VSP - 110

SUBJECT: Distribution of: **ALLIEDSIGNAL AEROSPACE Service Bulletin No. 103638-21-4062**
"Cracked Polycarbonate - Plastic Outflow Valve Poppet"

SERVICE BULLETIN

AIR CONDITIONING -- Outflow/Safety Valve -- Identification of valves that require replacement

Outflow/Safety Valve Identification Plate
Figure 1

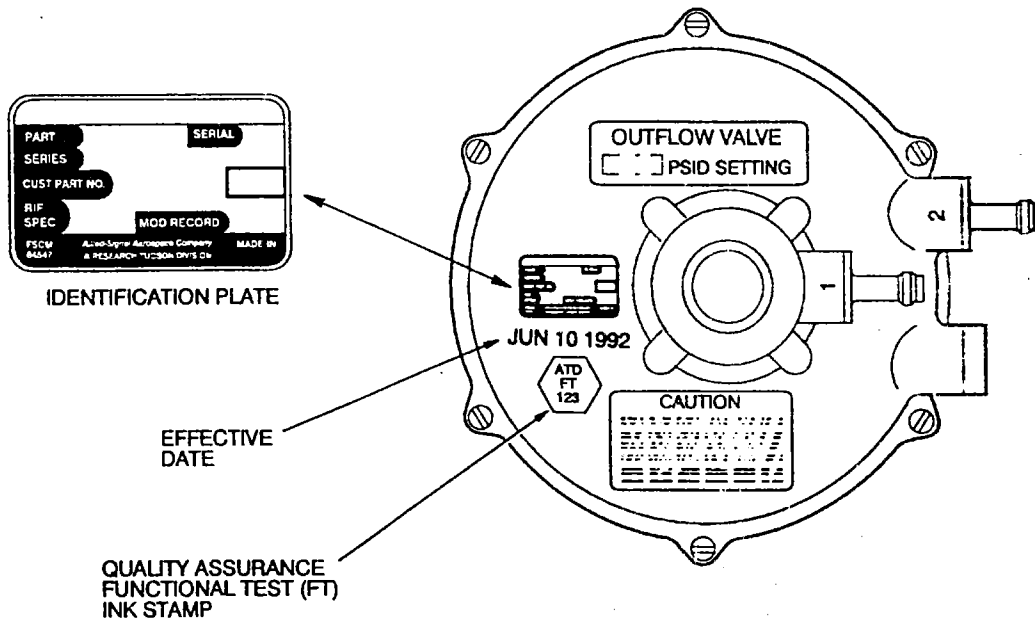
- A. Visually check the valve serial number appearing on the identification plate against the effectivity list. (See figure 1.) If the serial number of the valve appears on the effectivity list, replace valve in accordance with aircraft manufacturers instructions, unless one of the following conditions is satisfied.
- B. If the serial number of the valve appears on the effectivity list, but the identification plate MOD RECORD block contains "PCA," no further action is required and the valve is considered serviceable.
- C. If the serial number of the valve appears on the effectivity list, but the valve cover has an inked ATD Quality Assurance "Functional Test (FT)" stamp dated June 1992, or later, no further action is required and the valve is considered serviceable. (See figure 1.)
- D. Reidentification
